**NRC Public Meeting  
Fukushima Near-Term Task Force Recommendation 2.1  
Seismic Re-evaluation and Screening Results**

**Surry Power Station - Units 1 and 2  
Millstone Unit 2**

**Dominion  
June 25, 2014**

TABLE 2.3.2-1 (Reference 7.9, 7.11):  
Surry Power Station Site Geotechnical Profile Data

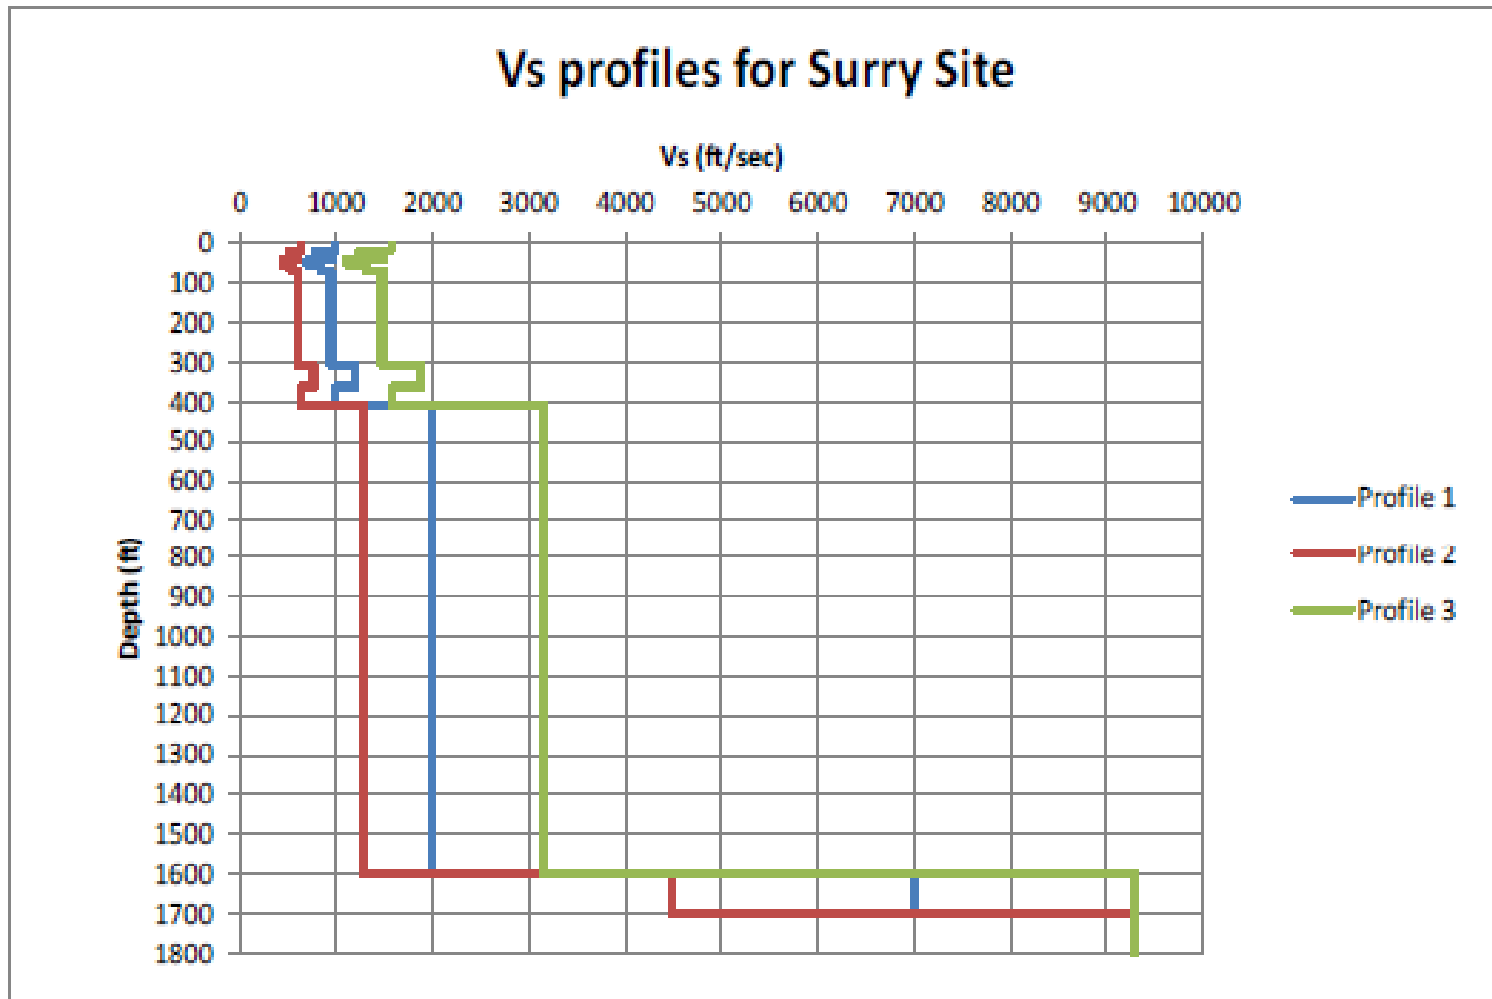
- Basis for Shear Wave Velocity (Vs) Profiles
  - Site-specific geotechnical profile data from Report Table 2.3.2-1
  - SSE control point at surface (26'6 El.)
  - Vs values
    - Compacted fill – 16' – 1000 fps
    - Upper 140' – based on sampler penetration tests (hammer blows)
    - Uncertainty factor of 1.57 applied based on limited data
  - Profiles reflect site-specific estimated Vs values
  - No gradient applied since soft soil site (consistent with SPID)

# Calculation of Kappa

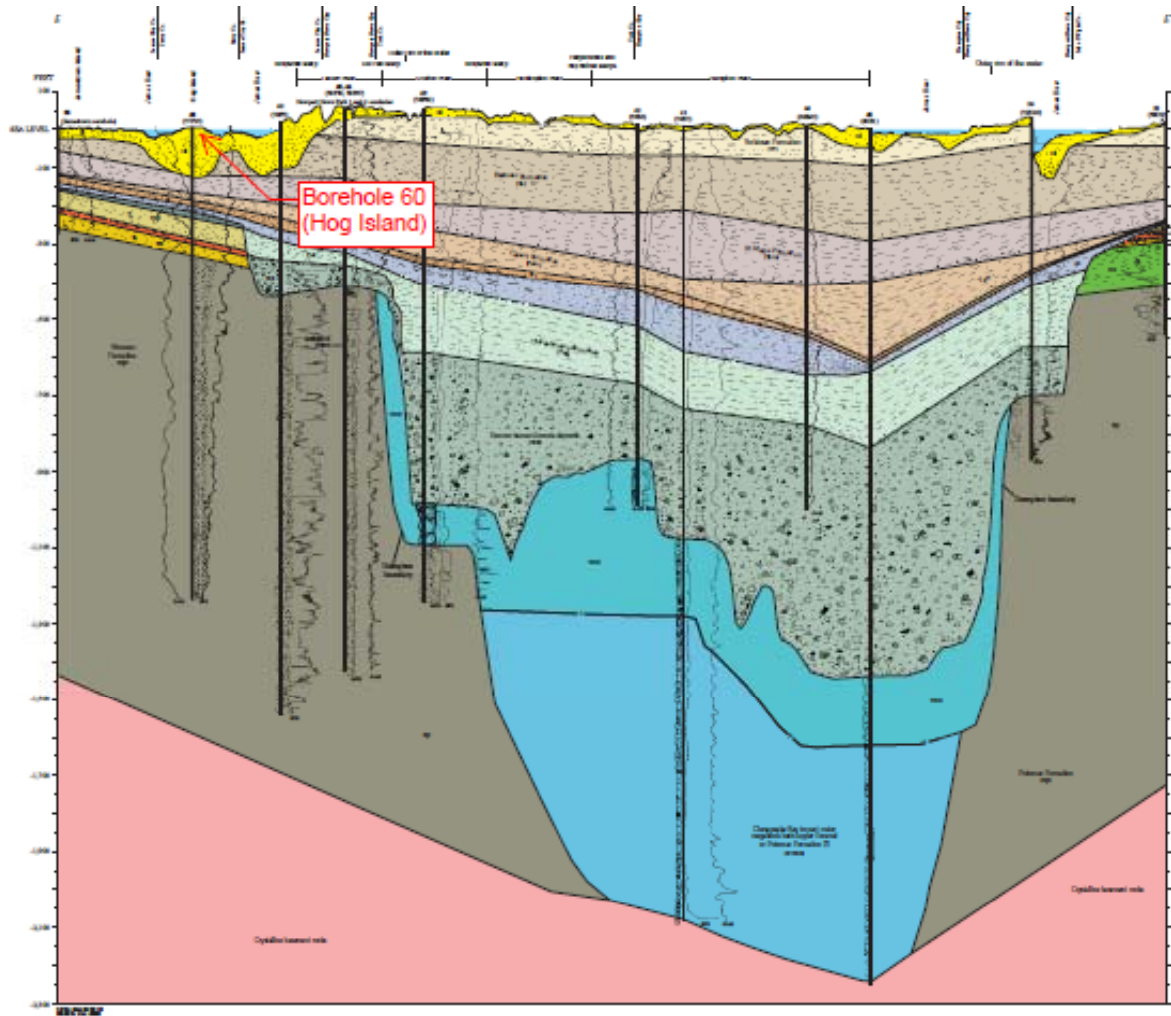
- Basis For Estimate of Total Effective Kappa
  - $Kappa = 0.034s$  based on SPID Appendix B.5.1.3.1 guidance for soil site with  $<3,000$  ft depth to hard rock
  - Contributions from soil ( $\approx 1,600$  ft) plus underlying hard rock
  - Soil contribution from empirical relation based on soil depth
  - Hard rock contribution  $0.006s$

# Depth to Hard Rock

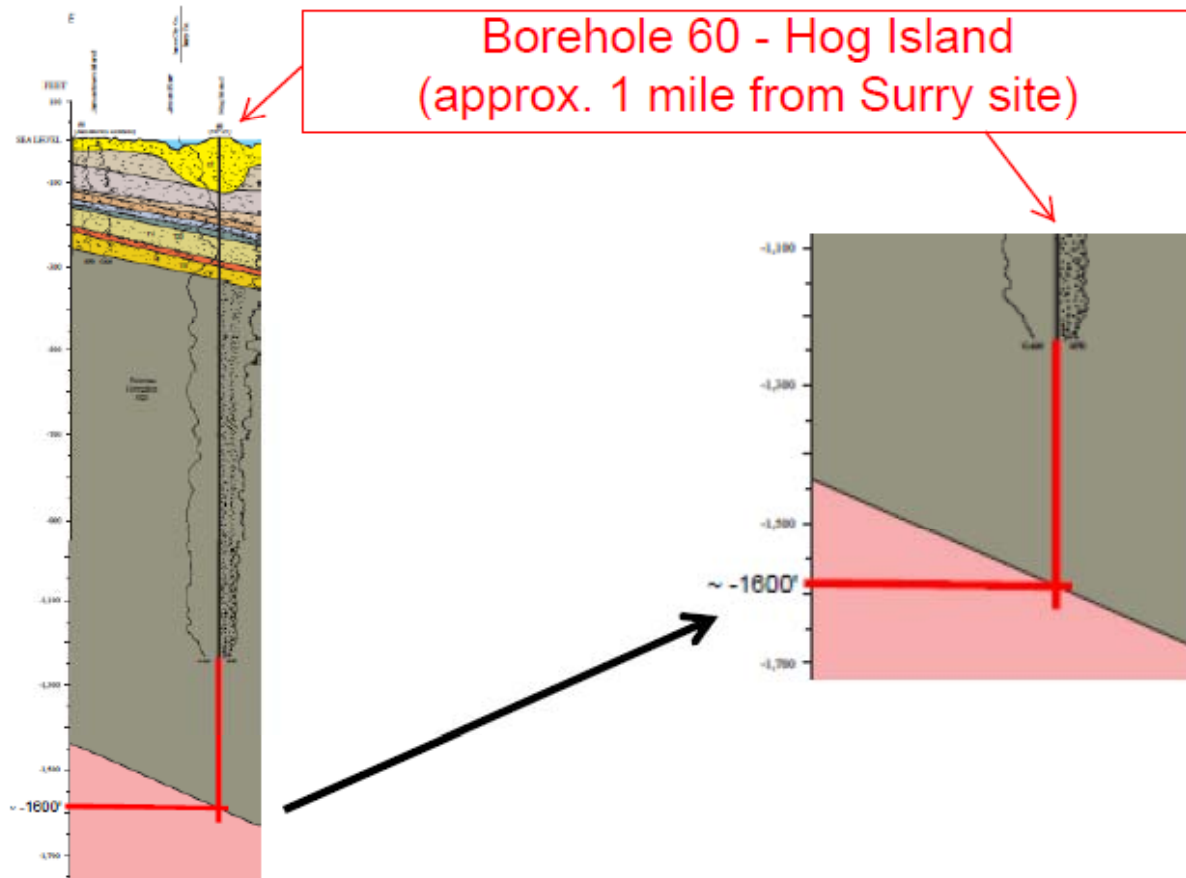
- Surry Screening Report: ‘Hard rock’ (i.e., shear wave velocity,  $V_s$ , >9200 ft/sec) elevation reported as -1700’
- Based on review of USGS Professional Paper No. 1612 (Feb 22, 2000)<sup>1</sup>
- Extrapolation of borehole 60 (Hog Island) [Plate 4] – indicates ‘crystalline basement rocks’ reached at approximately -1600’
- Additional 100’ depth to  $V_s=9200$  ft/sec was assumed in order to account for likely weathering effects during the period the Potomac formation was being deposited
